UNITED STATES PATENT AND TRADEMARK OFFICE

APPLICATION NO.	FILING DATE	FIRST NAMED INVENTOR	ATTORNEY DOCKET NO.	CONFIRMATION NO.
10/553,384	10/19/2005	Kazuhiko Ueda	FUKAP0105US	3656
43076 7590 12/05/2007 MARK D. SARALINO (GENERAL) RENNER, OTTO, BOISSELLE & SKLAR, LLP 1621 EUCLID AVENUE, NINETEENTH FLOOR CLEVELAND, OH 44115-2191			EXAMINER NGUYEN, TRAN N	
			ART UNIT 2834	PAPER NUMBER
			MAIL DATE 12/05/2007	DELIVERY MODE PAPER

Office Action Summary	Application No.	Applicant(s)	
	10/553,384	UEDA, KAZUHIKO	
	Examiner	Art Unit	
	Tran N. Nguyen	2834

DETAILED ACTION

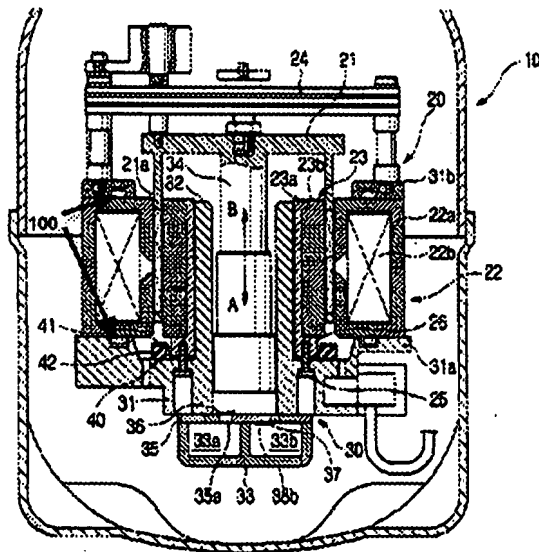
- A linear motor (30, Fig. 2) having an inner yoke (23, Fig. 2) and an outer yoke (22, Fig. 2) outside said inner yoke.
- A coil-wound body (22b, Fig. 2) and a movable magnet portion (21, Fig. 2) for driving a piston (34, Fig. 2) reciprocating in a cylinder (31, Fig. 2), both located between said inner yoke and said outer yoke.

- A first and second clamping members (31a and 31b, Fig. 2) for clamping said outer yoke, and a spacer (100, edited Fig. 2; par. 41, lines 11-15)) for coupling (par. 41, lines 1-15) said first and second clamping members at a given spacing.
- The first clamping member (31b, Fig. 2) being provided with a support portion (20, Fig. 2) for supporting a spring (24) for pushing said piston, and a second clamping member (31a, Fig. 2) being fixed directly or indirectly to the cylinder (31, Fig. 2).

In re claim 2, the spacer (100, edited Fig. 2) has axial end faces and smaller-diameter portions (100, edited Fig. 2) protruding from the axial end faces at both ends, and the first and second clamping members (31a and 31b, Fig. 2) have first and second receiving portions (200 and 300, edited Fig. 2) having concave portions for receiving said smaller-diameter portions of said spacer and support surfaces for supporting the axial end faces of said spacer.

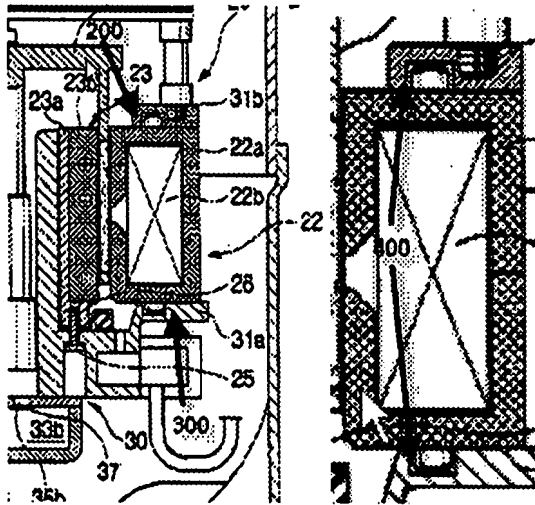
as shown in Chang's original Fig 2, the first and second clamping members (31a and 31b, Fig. 2) holding the outer yoke therebetween;

a spacer (100 as shown in Chang's edited Fig 2) for coupling said first and second clamping members at a given spacing therebetween the two clamping members, wherein the clamping members are respectively provided with a receiving portions that are configured as concave portion (200 and 300, edited Fig. 2) for receiving the spacer there within.

Chang's through bolt 100 (given pictorial reference number 100 in the edited Fig 2) couples the two clamping members 31a and 31b at given spacing. That is the two clamping members are positioned at the motor's two respective ends at a given spacing therebetween. As, stated by the applicant "*the spacing between the clamping members 31a and 31b is defined by the outer stator 22*" this statement correctly points out that that there is spacing between the two clamping members (31a, 31b). It is irrelevant whether that given spacing between the between the clamping members is for accommodating the outer yoke 22, as in Chang's motor, or accommodating only the spacer 5 therebetween, as in the present invention, because the claimed language simply recites "*a spacer for coupling said first and second clamping members at a given spacing*".

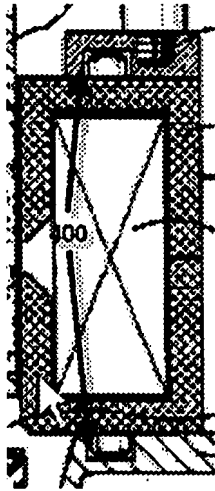
In re claim 5, Chang '459 discloses the first and second clamping members (31a and 31b, Fig. 2) are coupled together with a gap (400, edited Fig. 2) provided between said first and second yoke blocks (22a, Fig. 2).
